Jackson Town Council Regular Meeting

April 17, 2023

P22-253 Development Plan for 245 and 265 N. Millward St. – Continued. Paul Anthony, Katelyn Page, and Brian Lenz made staff comment. Adam Janak, Hans Flinch, Patrick Woodward, and Josh Kilpatrick made applicant comment. Rose Robertson, Kimberly Kernan, Matt Gaffney, Stuart Suna, John Bickner, Diana Welch, Matt Bambach, and Eugenie Copp made public comment. Council asked questions of staff. A motion was made by Arne Jorgensen and seconded by Jessica Sell Chambers to continue P22-253 to the regularly scheduled Town Council meeting on April 17, 2023. Mayor Morton Levinson called for the vote. The vote showed all in favor. The motion carried.

0 4 8 16 32

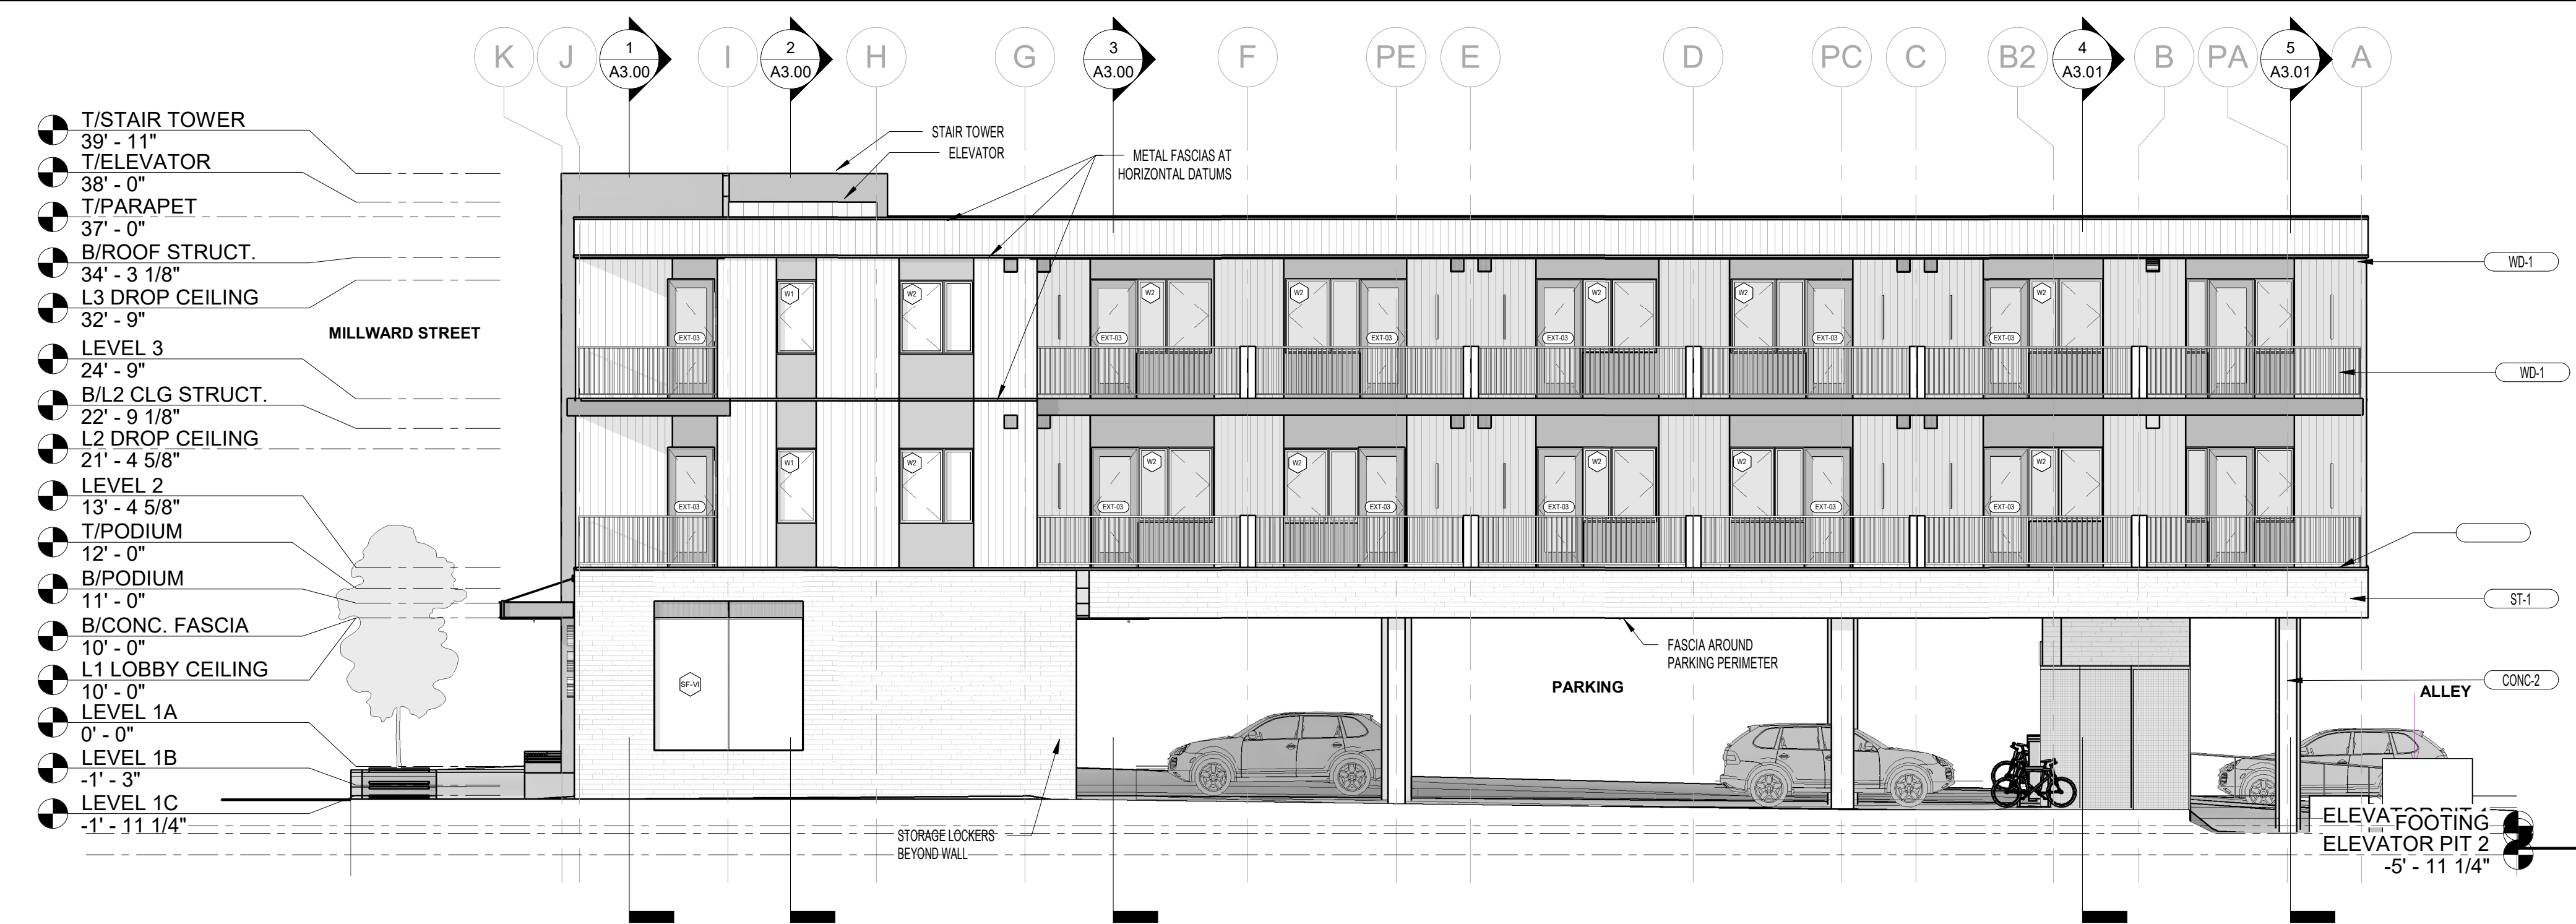
- Building Frontage (Shopfront vs. Office Frontage). Revise LDR compliance table to select only one (it is not tied to use) and to list subcategory compliance, specifically story height, transparency, blank walls, ped access. Revise elevations and floor plans to call out subcategory compliance (for frontage type) such as transparency requirements. May be similar to applicant providing stepback calcs on pg 37 of submittal packet. **Updated in LDR Compliance table and in architectural plans and elevations. See A2.00 for façade calculations.**

- P.51-54 – **Unit Mix overview was updated.**
Color coding of deed-restricted units changed. Reduced plan to 48 units total.
- P.55-57 (A2.00-A2.02) – **Bulk reduced at alley elevation.**
Overhangs eliminated at corridors; central balcony pushed back and its roof eliminated.

C1.1

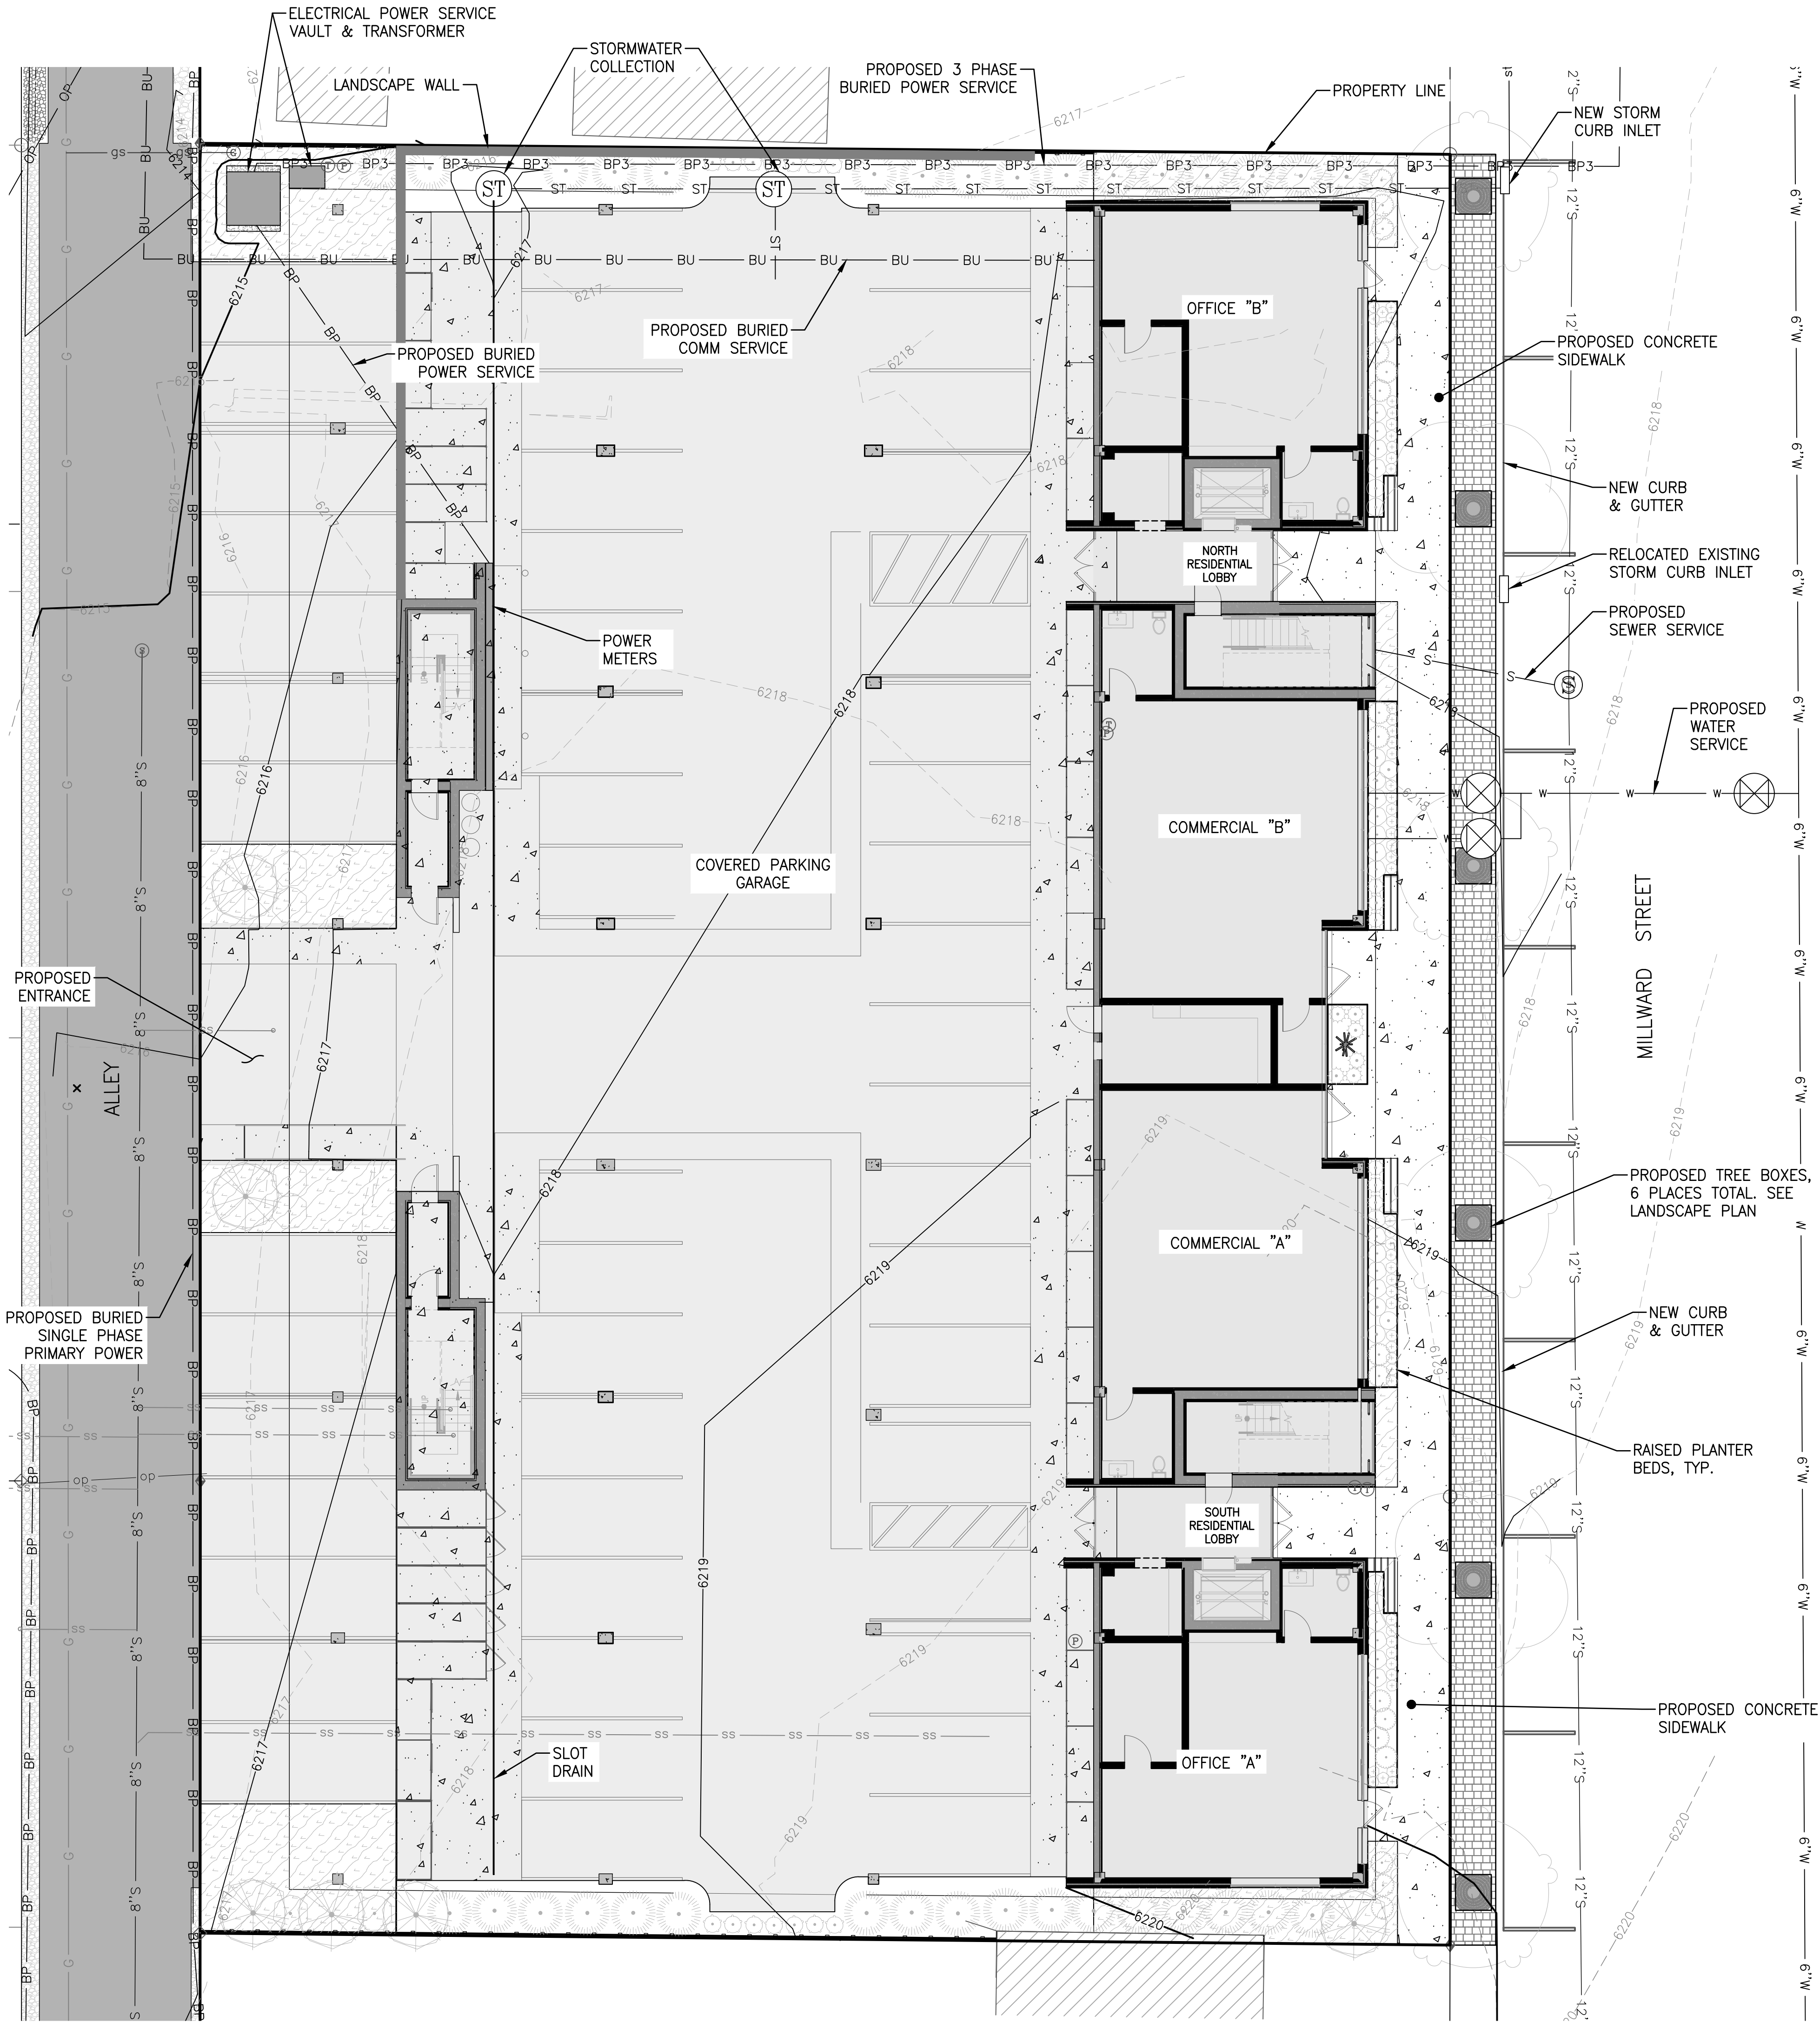
- 1) A1.01: Potential conflict with building columns and vehicle doors. Review and revise accordingly.
- 2) C1.1 - Construction Tracking Pad detail is not feasible in this location and conflicts with the proposed grates in the construction management plan. Review and revise accordingly.

ALLEY DEVELOPMENT PLAN

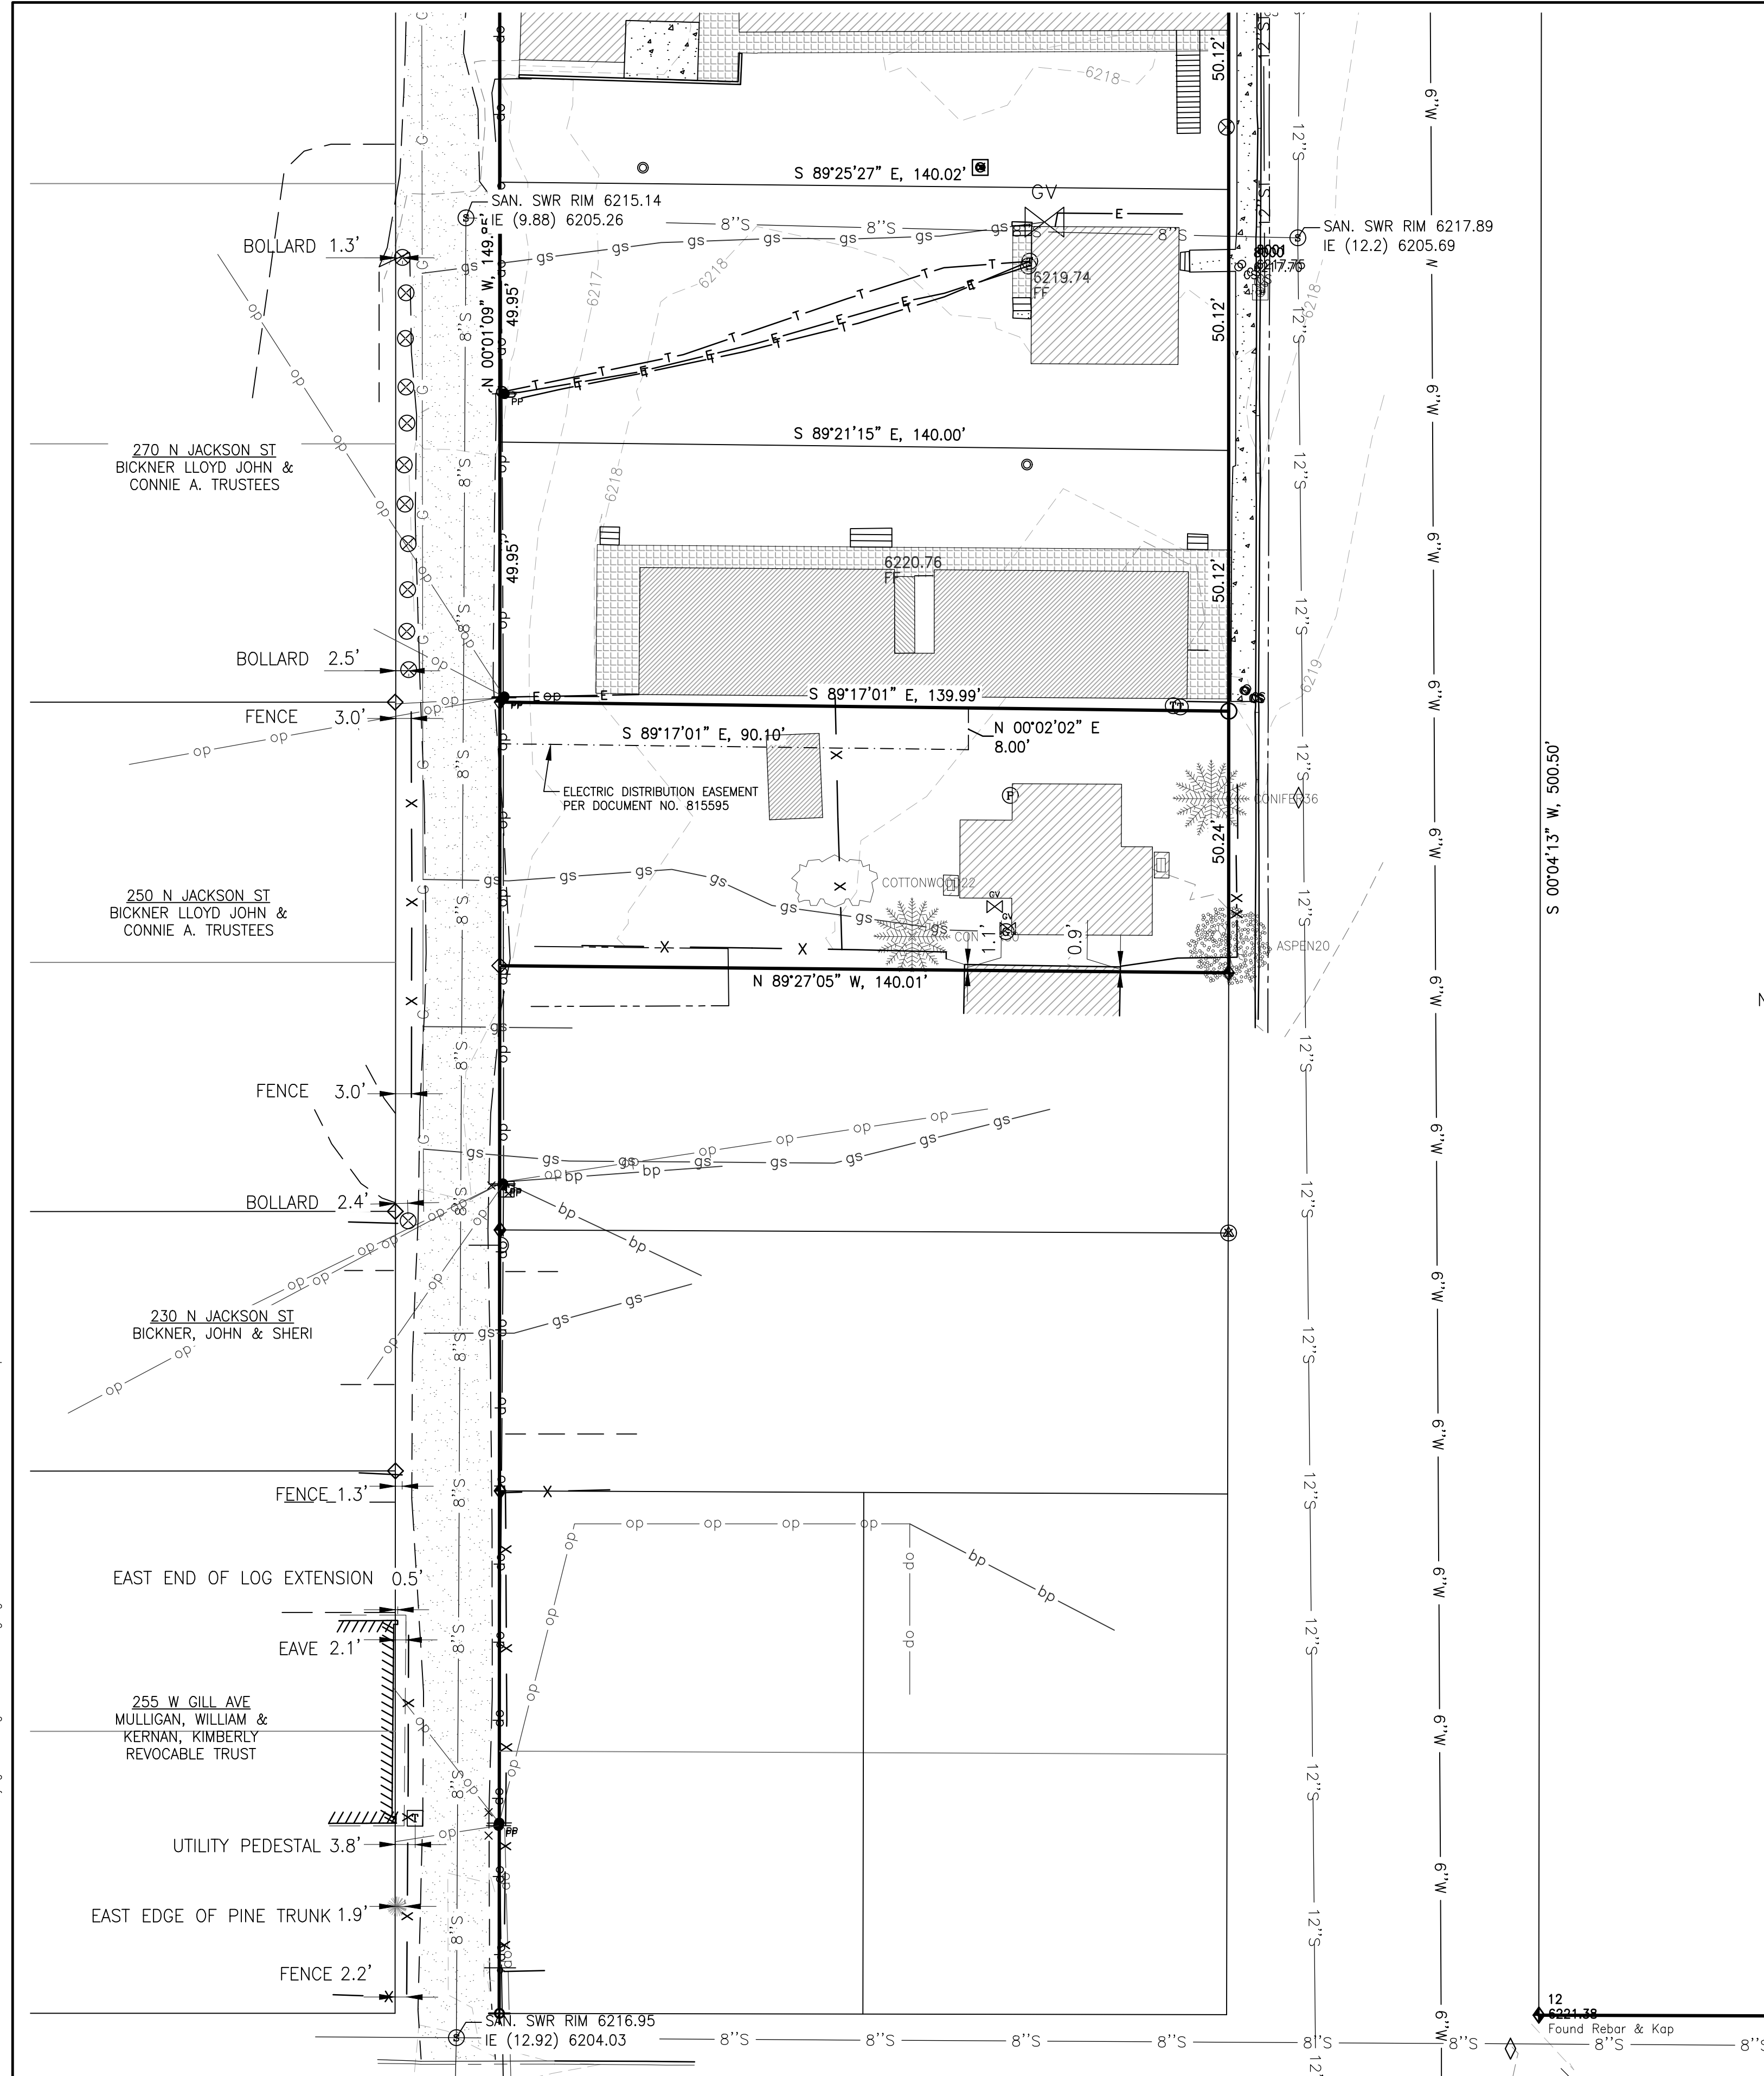
- P.92-93 (C4.3, Existing Alley Survey) – **Proposed and existing alley site plans were drawn, and a new stormwater retention strategy was proposed.**
The alley and its existing encroachments have been surveyed. Excess stormwater is being retained pre-post on site.
